Rezoning Transportation Analysis

Petition Number: 2022-209

General Location Identifier: 12520104

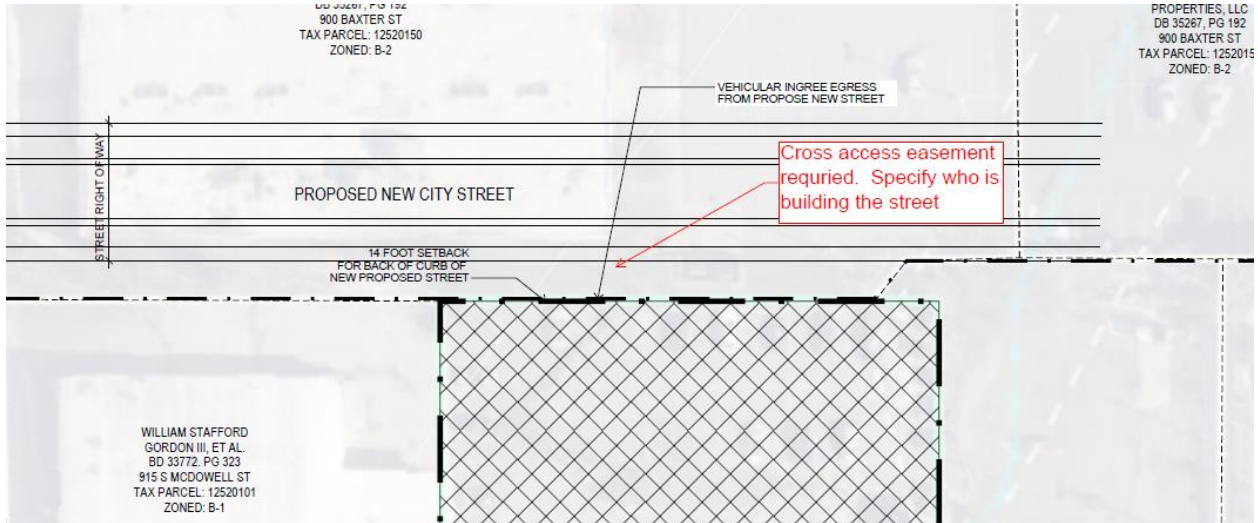
3. ~~Revise site plan and conditional note(s) to commit to dedicate a minimum of 40-foot of right-of-way from the road centerline. The site plan shall label and dimension the right-of-way from the road centerline. In addition, provide sidewalk utility easement if the proposed sidewalk facility will be located outside of the ROW.~~
4. ~~Revise site plan and conditional note(s) to extend the existing concrete median along Morehead to the Dilworth Road connector.~~
